Committee:	Date:
Planning Applications Sub Committee	17 April 2024
<p>Subject:</p> <p>London Wall West, 140 London Wall, 150 London Wall, Ironmongers' Hall, Shaftesbury Place, London Wall Car Park, London, EC2Y (including Void, Lifts And Stairs At 200 Aldersgate Street And One London Wall) London EC2Y 5DN</p> <p>23/01304/FULEIA: Demolition of 140 & 150 London Wall to provide a phased development comprising: the construction of new buildings for a mix of office (Class E(g)), cultural uses (Sui Generis) and food and beverage/cafe (Class E(b)), access, car parking, cycle parking and highway works including reconfiguration of the Rotunda roundabout, part demolition and reconfiguring of the Ironmongers Hall (Sui Generis), creation of a new scheduled monument viewing area, public realm alterations to Plaisterers Highwalk, John Wesley Highwalk, Bastion Highwalk and Mountjoy Close; removal of two highwalks known as Falcon Highwalk and Nettleton Court; alterations to the void, lifts and stairs at 200 Aldersgate Street and One London Wall, introduction of new City Walkway.</p> <p>23/01277/LBC: External alterations to existing highwalks at the Barbican Estate including to the John Wesley High

Figure 3 – Phase 2 of St Paul's Gyratory Transformation Project

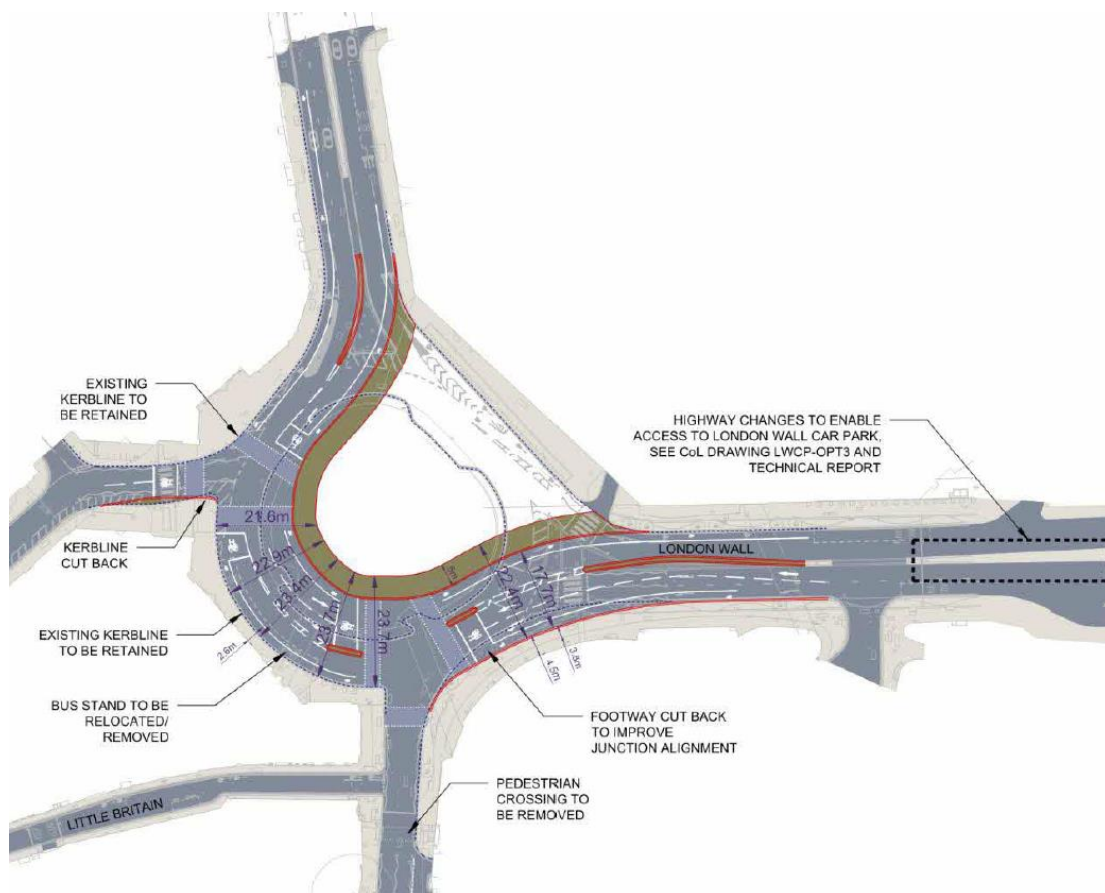
638. It can be seen in Figure 3 that the Phase 2 proposals would see Aldersgate Street and London Wall connected via a two-way road broadly following the alignment of the south-western section of the existing roundabout. The roundabout carriageway would be widened to allow for two-way running, cycle lanes and turning lanes. The north-eastern segment of the roundabout would be

Figure 7 – Proposed London Wall Car Park Access Arrangement

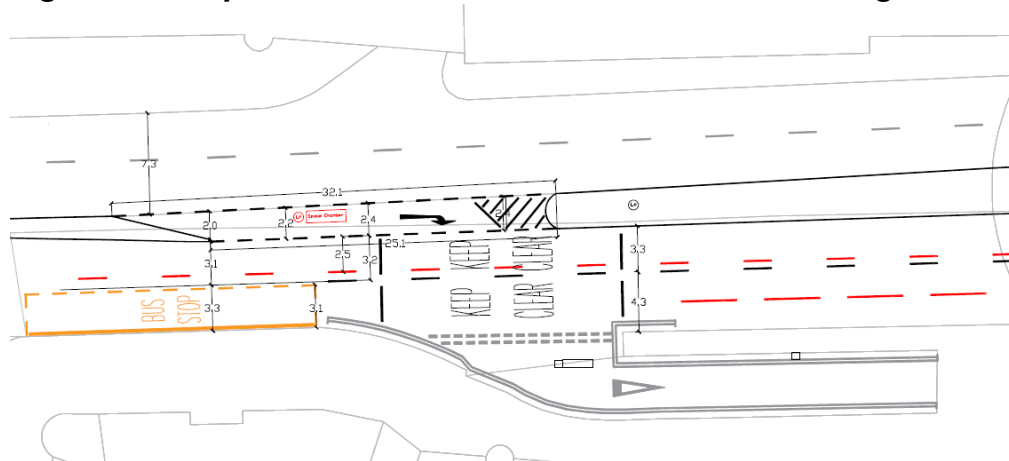
688. The length of the right turn bay would enable two vehicles to wait for a turning opportunity. The location of the signalised junction at Wood Street / London Wall (which runs on an 88 second cycle and has an all-red stage for pedestrians) would provide frequent opportunities for vehicles to filter during busy periods. A Picady traffic model should be prepared as part of the required Highways Improvement Works design process to inform design requirements in this regard.

Figure 12 – Proposed Signal Control Arrangements

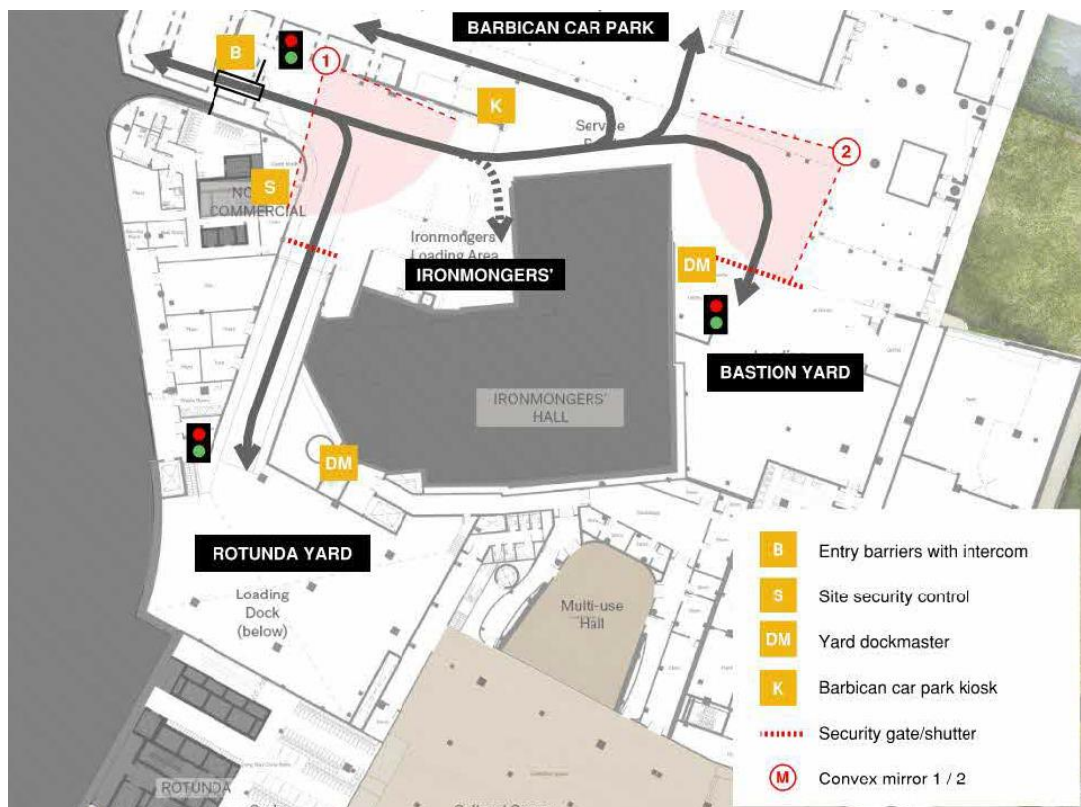
741. The introduction of traffic signals would be a notable change from the existing access operations, which are 'free flowing.' Given the interrelationship between

Figure 14 – Areas to be Stopped Up and / or Adopted

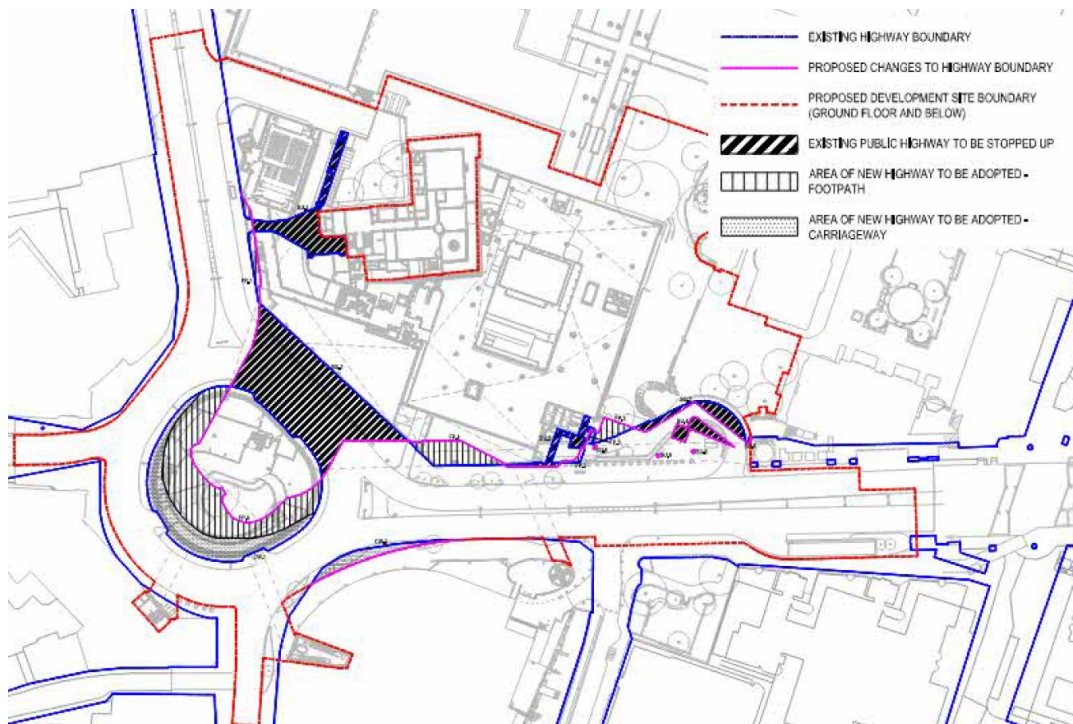
767. A draft stopping up / offering up plan has been produced by the applicant, as provided below, which illustrates the proposed changes. It is noted that this plan is preliminary and will be subject to further refinement and consultation with the City following any planning approval. The process to formalise stopping up orders can only be made at the appropriate point, notwithstanding the plans are considered acceptable in principle at this stage.

Figure 17 – Existing and Proposed City Walkways (Podium Level)

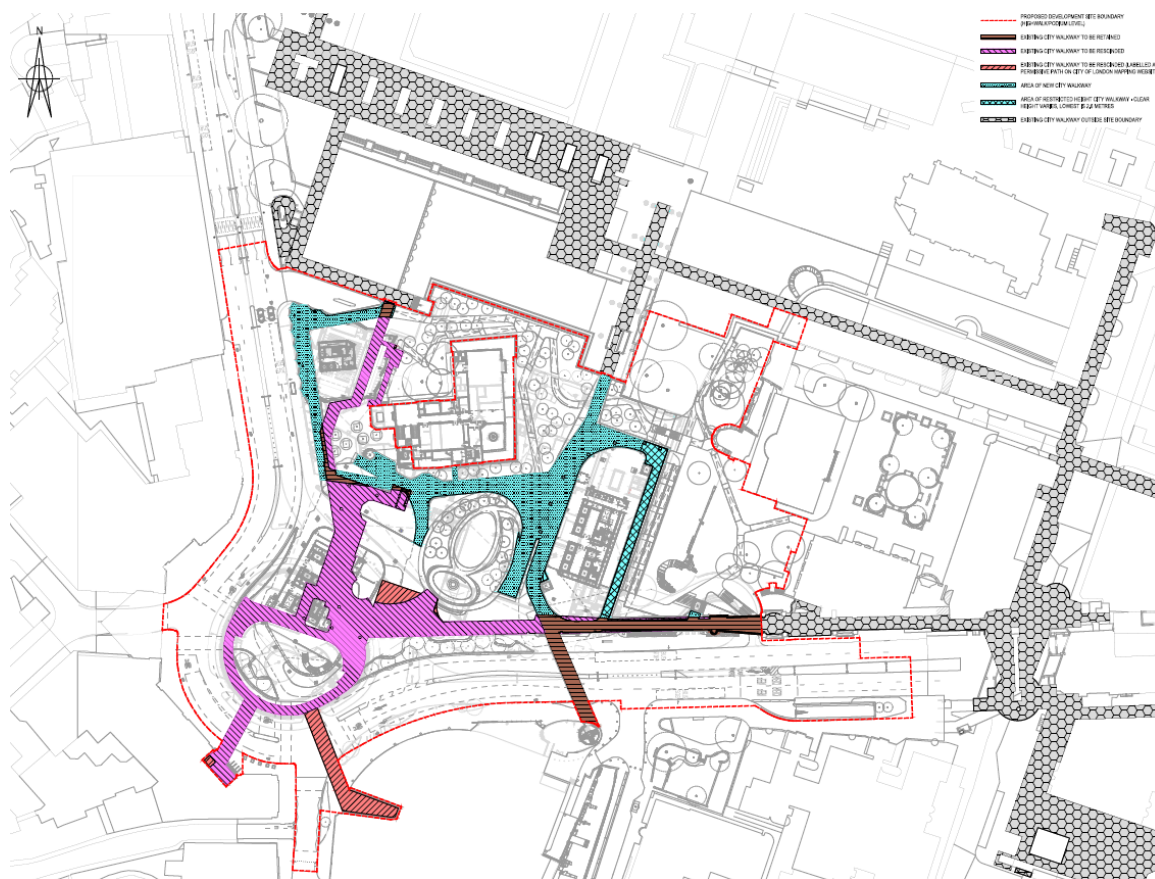
775. Generally, it can be seen that all primary circulation routes at podium level are proposed as City Walkways.

Figure 21 – Extent of Undersailing Requirements

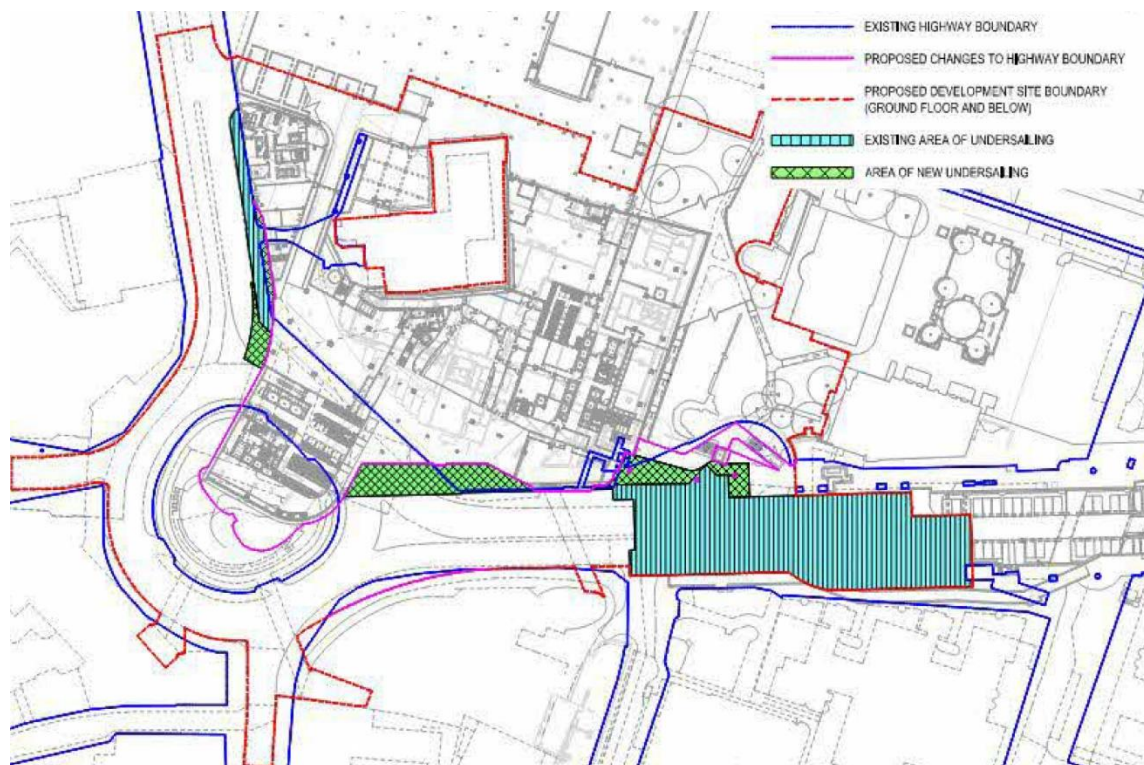
795. Should planning permission be granted an AIP will be required to be set as a condition and on this basis the proposed oversailing is considered acceptable in principle.
